## 88 Cambridgepark Drive

Submittal for Planning Board Review

The McKinnon Company *on behalf of* BRE/CPD, LLC // Cambridge, MA // 12 August 2014

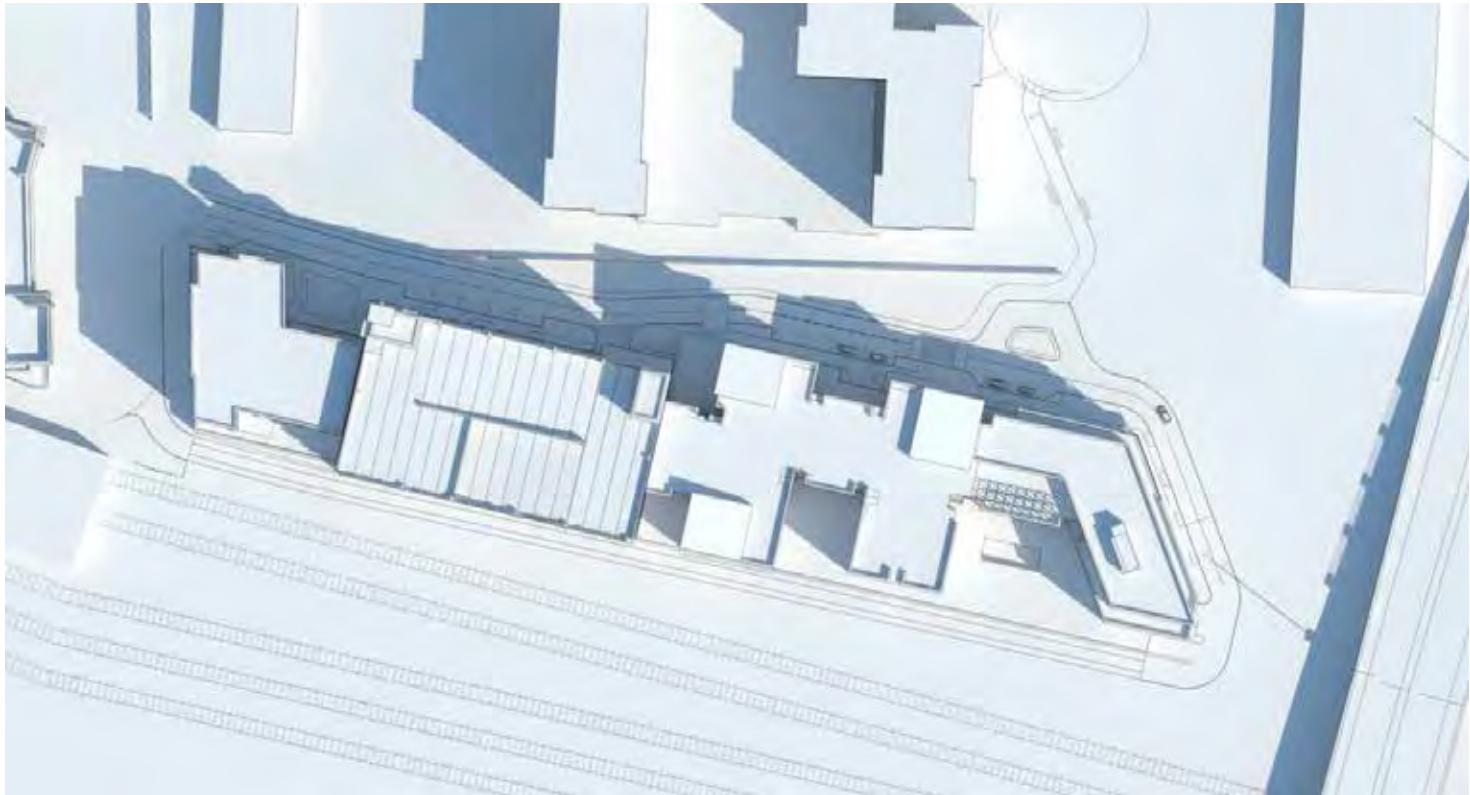
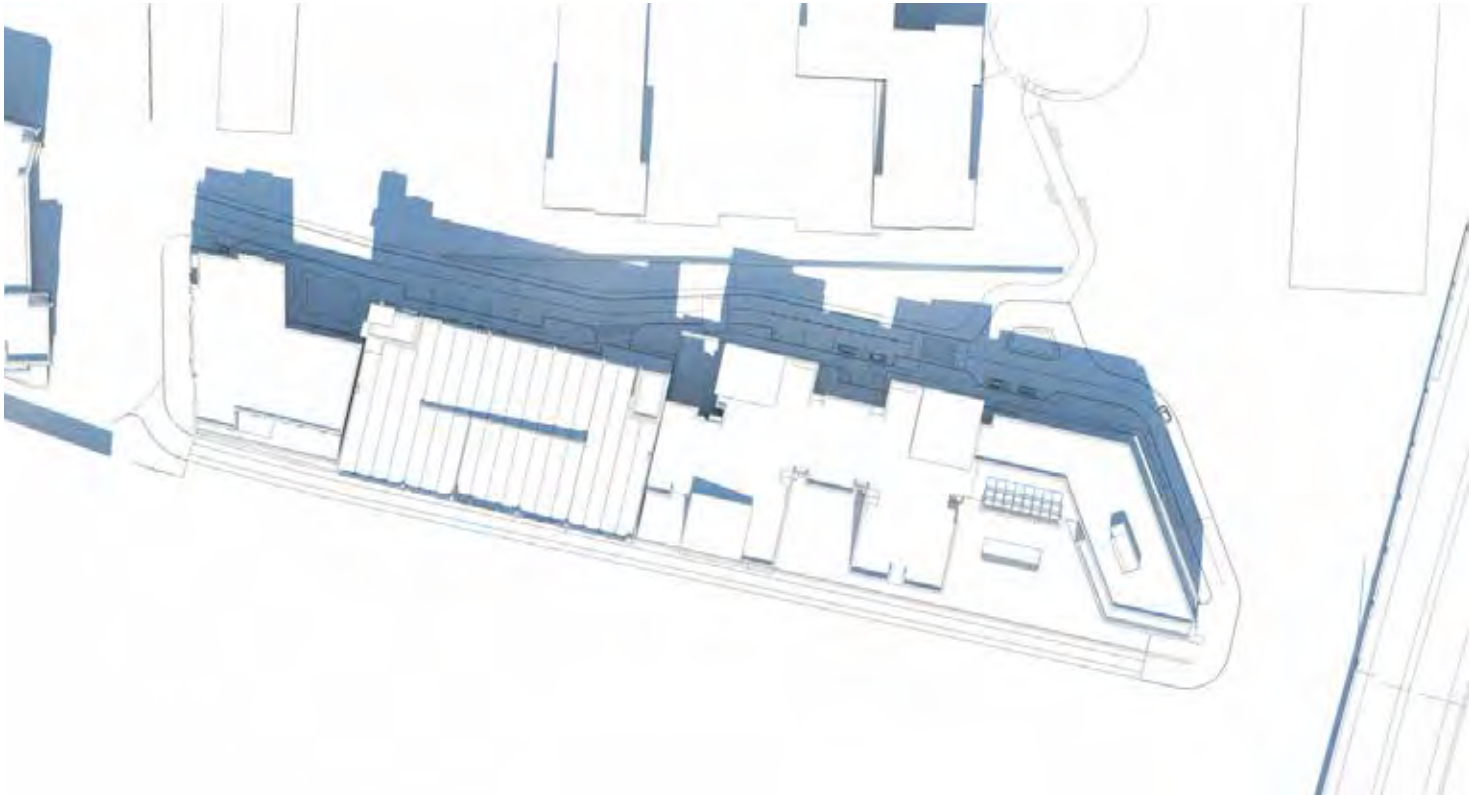
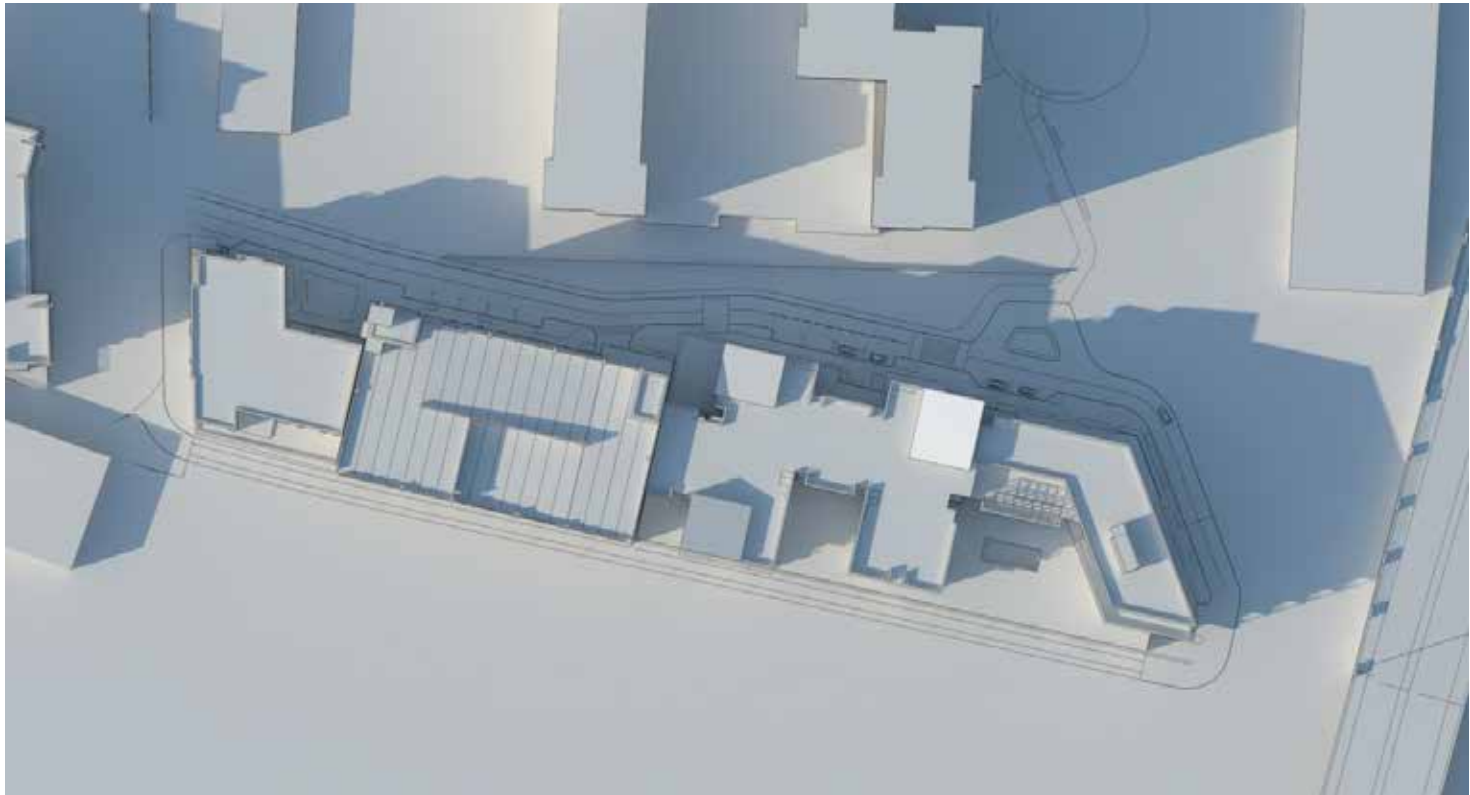
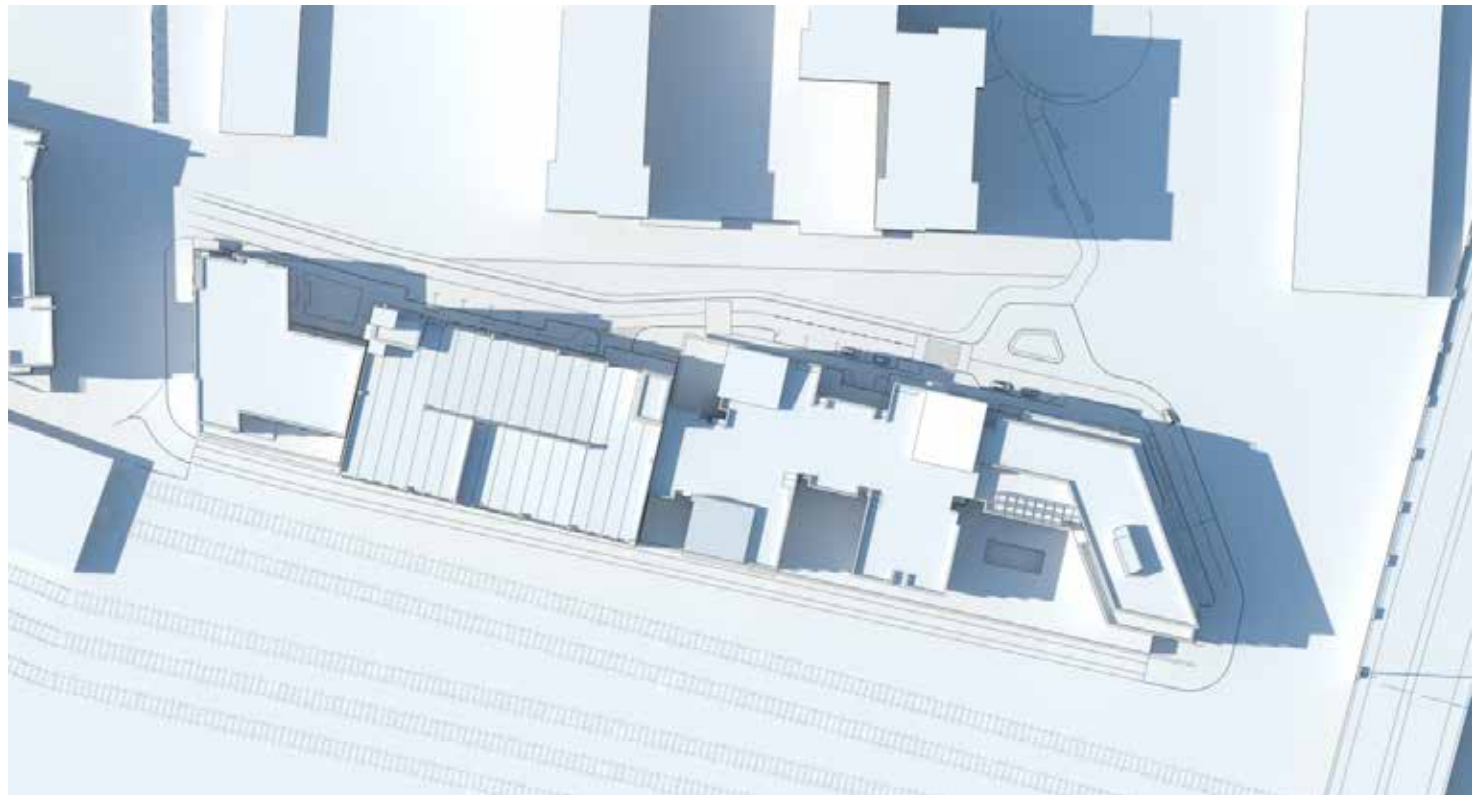
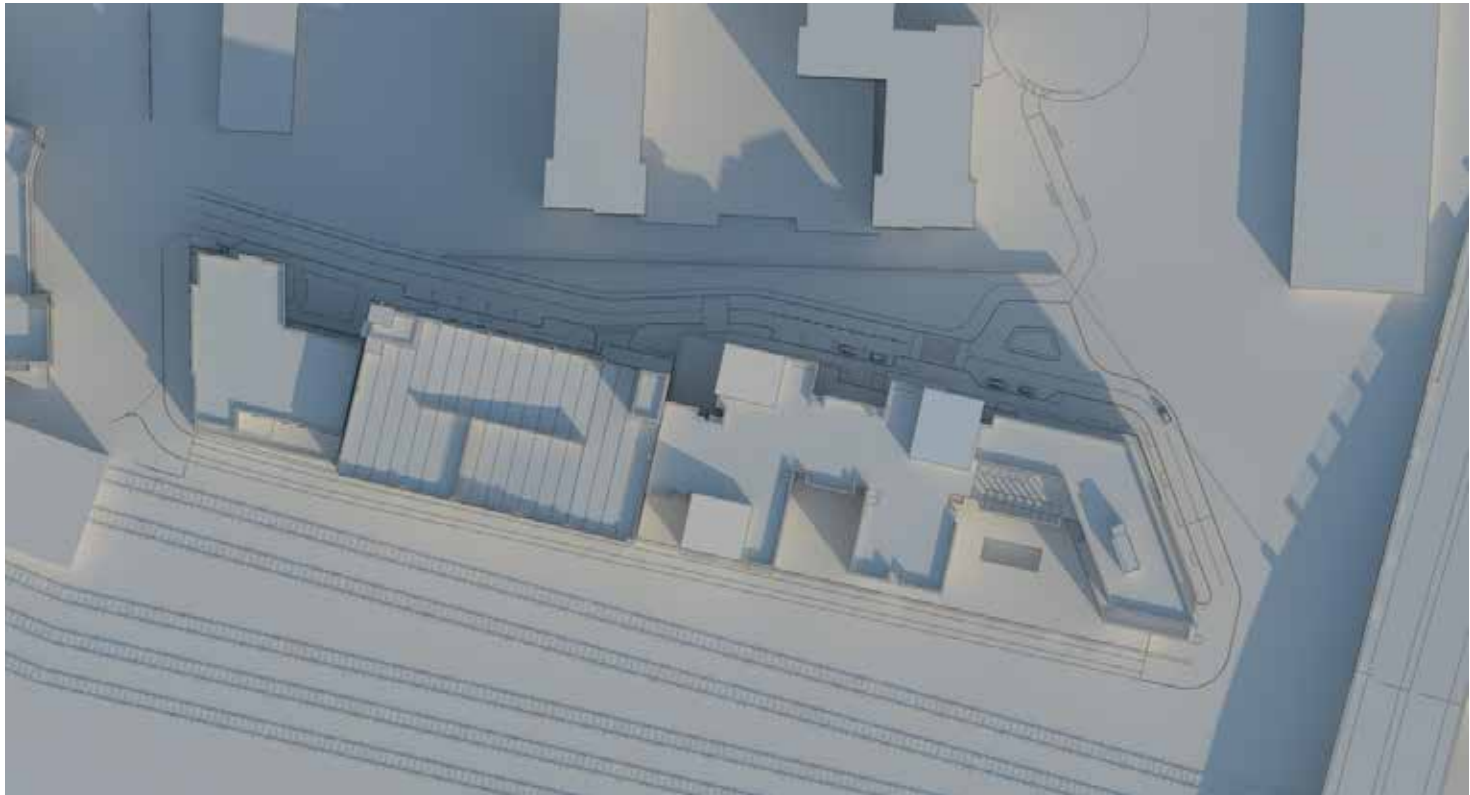
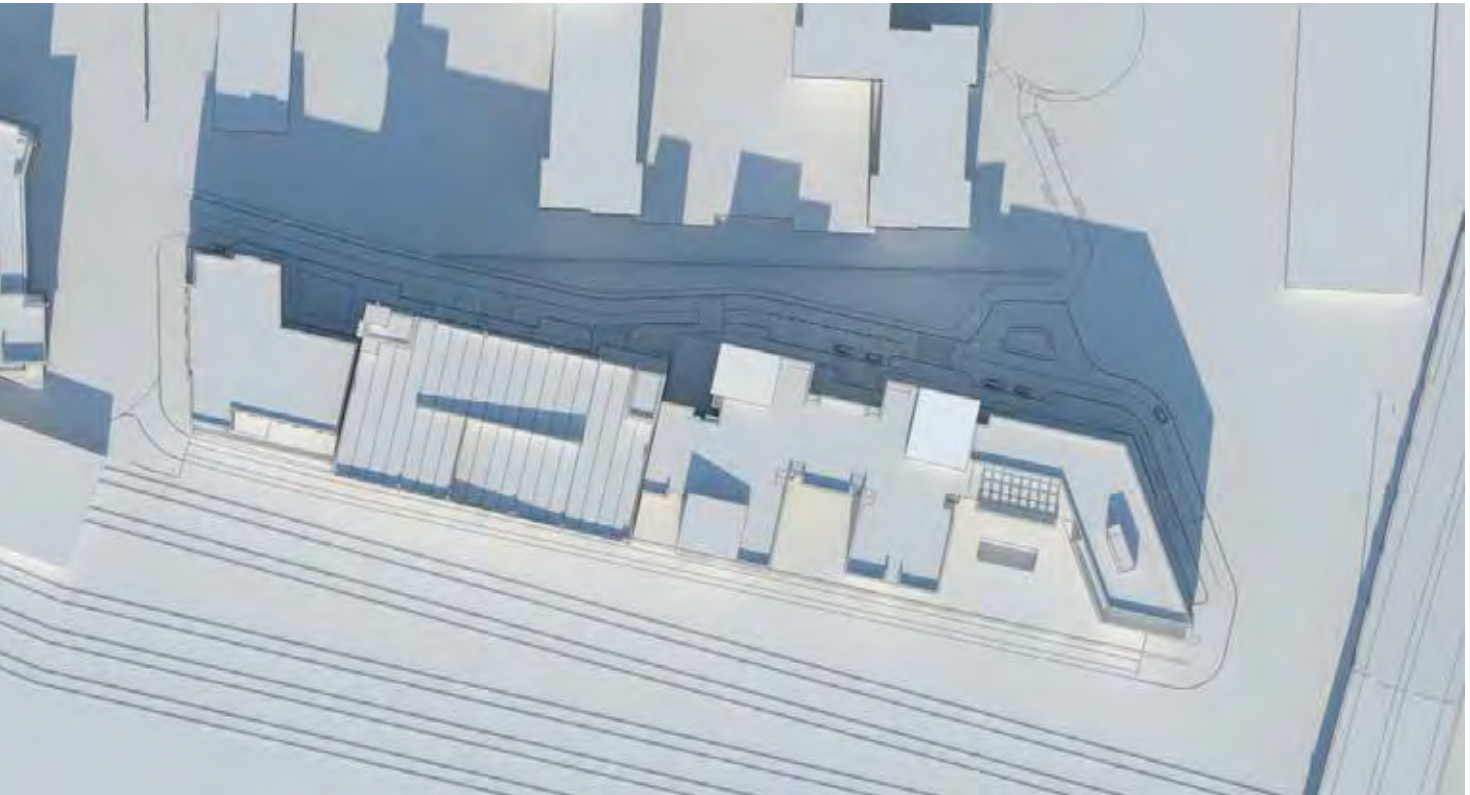
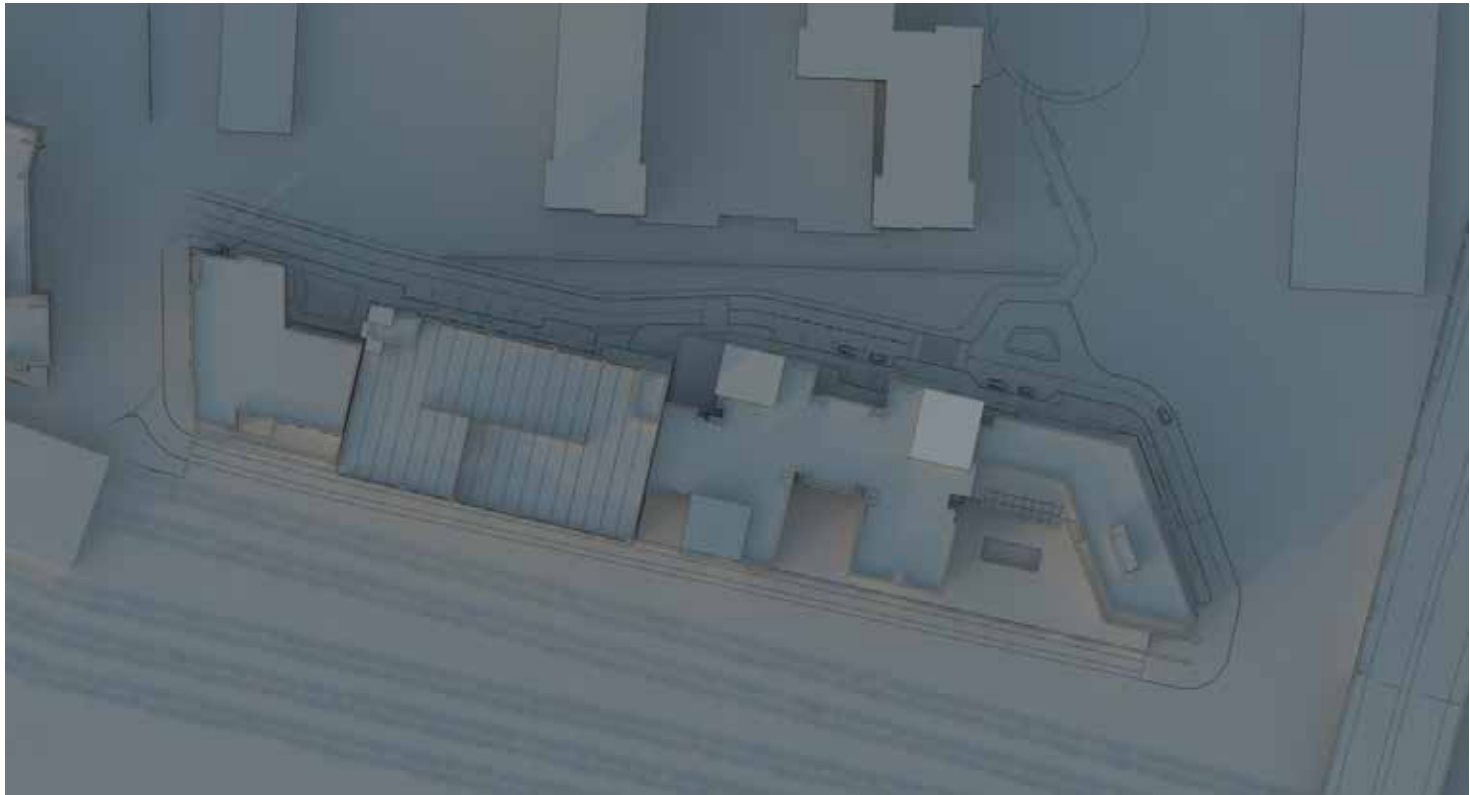
8. SHOW SHADOW STUDIES; NOTE WHERE MECHANICAL EQUIPMENT IS LOCATED

Shadow studies are included in the submittal. These studies at generally accepted key hours of the day at different times of year, show a modest shadow impact that for the most part avoids shading the south-facing second level open space of 30 CambridgePark Drive. Mechanical equipment in these residential buildings of this scale is typically low roof-top systems located centrally on the roof that do not increase shadows at grade. (Office buildings have taller roof-top systems; if the project had maintained the originally-proposed 110’ height there would have been larger roof-top systems, which are not anticipated in this redesign.) To avoid a monotonous 70’ height, the project redesign includes angled roof parapets which give the appearance of taller sections without exceeding the 70’ height as defined in the City’s zoning ordinance.
